HISTORIC AND DESIGN REVIEW COMMISSION

HDRC CASE NO: 2020-197
ADDRESS: 515 N PALMETTO
LEGAL DESCRIPTION: NCB 1371 BLK 3 LOT 33 34 & 35
ZONING: RM-4, H
CITY COUNCIL DIST.: 2
DISTRICT: Dignowity Hill Historic District
APPLICANT: Ricardo McCullough
OWNER: ONLY BRI INC
TYPE OF WORK: Construction of six, 2-story single-family residences
APPLICATION RECEIVED: April 16, 2020
60-DAY REVIEW: Not applicable due to City Council Emergency Orders
CASE MANAGER: Edward Hall

REQUEST:

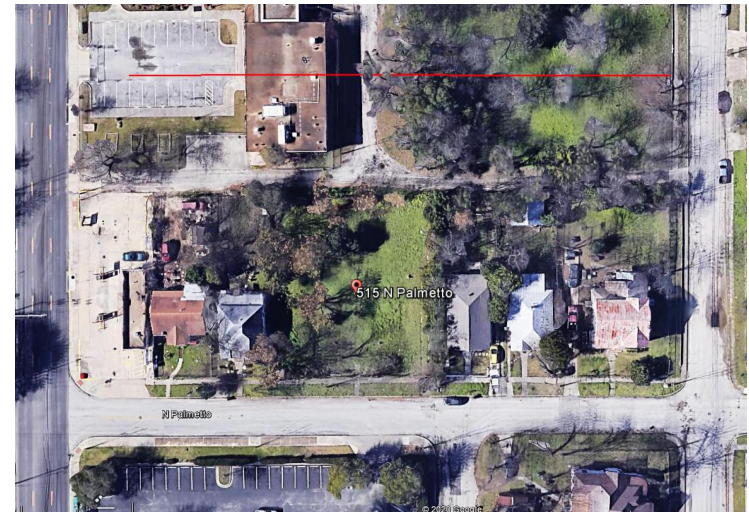
JG: If the 6-unit plan is to be approved, the driveways should extend all the way through the property from N palmetto to the alley instead of exclusive alley entry, and the 'front' parking pad on alley side should be removed.

JG: If the 6-unit plan is to be approved, there would need to be more appropriate backyard spaces. As proposed, neighbors can look down and into each other's properties from the second floor windows.

JG: 6 square units as proposed is too crowded, but one or two story is not a concern.

JG: The 3 one-story units plan would be more appropriate than 6 two-story units.

CONCEPTUAL FRONT ELEVATION

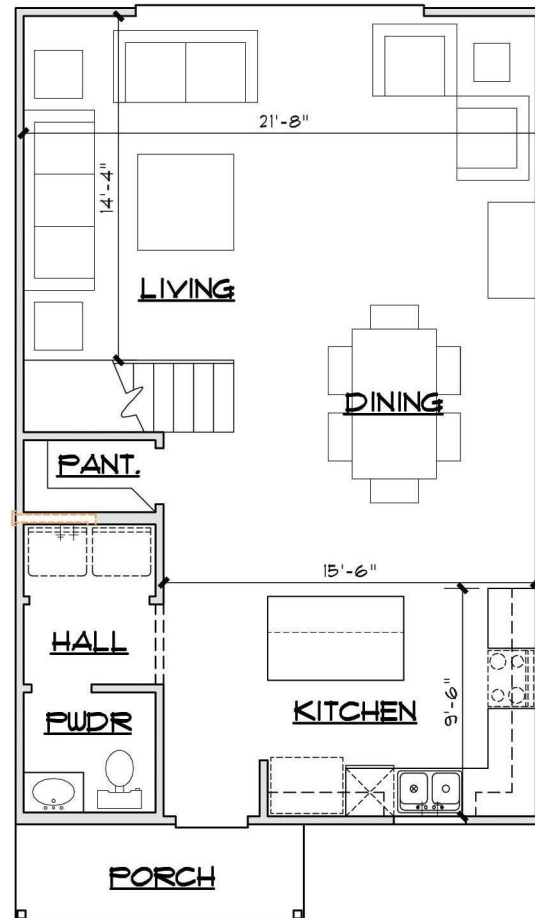
- k. **ROOF FORMS** – The applicant has proposed for each structure to feature both front and side gabled roofs. While these forms are found historically within the Dignowity Hill Historic District, staff finds that the proposed proportions and lack of a uniform gable height for both are inconsistent with historic examples found in the district. Staff finds that ridge lines of both the front and side gabled roofs should be uniform, as found on the historic structure at the corner of N Palmetto and Dawson.

- l. **WINDOW & DOOR OPENINGS** – Per the Guidelines for New Construction 2.C.i., window and door openings with similar proportions of wall to window space as typical with nearby historic facades should be incorporated into new construction. Per the elevation that the applicant has submitted, staff finds the proposed windows to be inconsistent with the Guidelines, as there are windows located on both the first and second floors on the primary façade that feature sizes that are not found historically within the district.

- m. **PORCH MASSING** – The applicant has proposed a front porch that consists of a stoop and roof element that is attached to the front façade of the historic structure. Porches found historically within the district feature massing that is incorporated into the massing of the structure, rather than simply attaching to the front façade, particularly in the case of two story structures. Staff finds that the proposed porch massing should be incorporated into the massing of the structure, as found on the historic structure at the corner of N Palmetto and Dawson.

- iv. That the applicant utilize foundation heights that are consistent with the Guidelines, as noted in finding j.
- v. That the applicant incorporate roof forms that feature matching ridge lines as noted in finding k.

- vi. That the applicant incorporate appropriate window sizes and proportions as noted in finding l.
- vii. That the applicant incorporate appropriate porch massing as noted in finding m.

CONCEPTUAL SITE PLAN

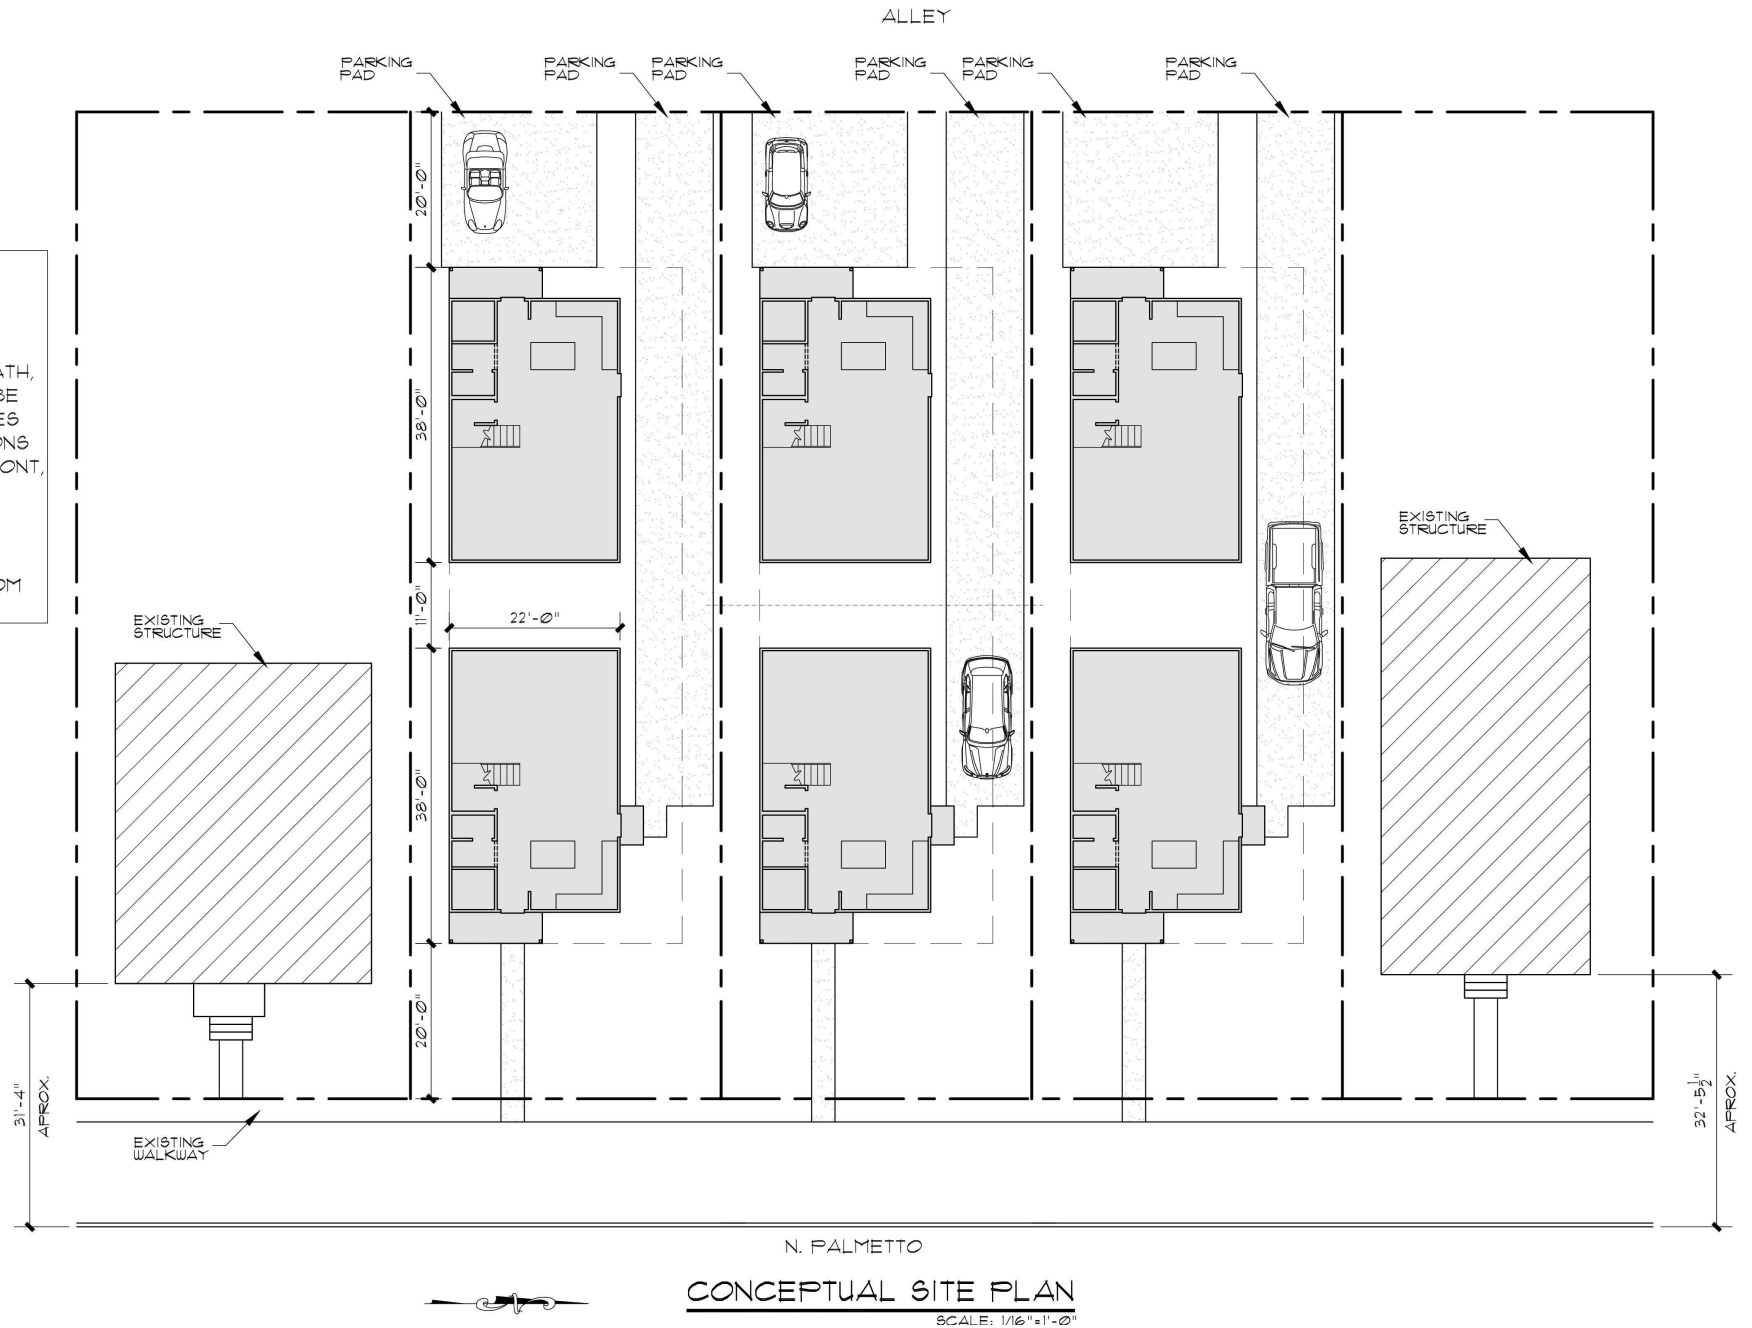
- d. **DESIGN REVIEW COMMITTEE** – This request was reviewed by the Design Review Committee on April 22, 2020. At that meeting, the committee noted that front yard parking pads should be removed, commented on driveway configuration and noted that three new structures rather than six would be most appropriate for the district.

- r. SITE ELEMENTS – The applicant has provided the location of walkways and driveways. Generally, the location of driveways and walkways is appropriate; however, staff finds that the proposed driveway lengths should be extended to the rear of each lot.

- i. That the applicant incorporate setbacks that are equal to or greater than those found historically on the block as noted in finding e.
- ii. That the applicant propose an overall building massing (width to height ratio) that is consistent with that of two story structures found historically within the district, as noted in finding f.

- iii. That the proposed structures on the rear alley be reduced in height and massing to be consistent with rear accessory structure found historically within the district (subordinate to the primary structure), as noted in finding g.
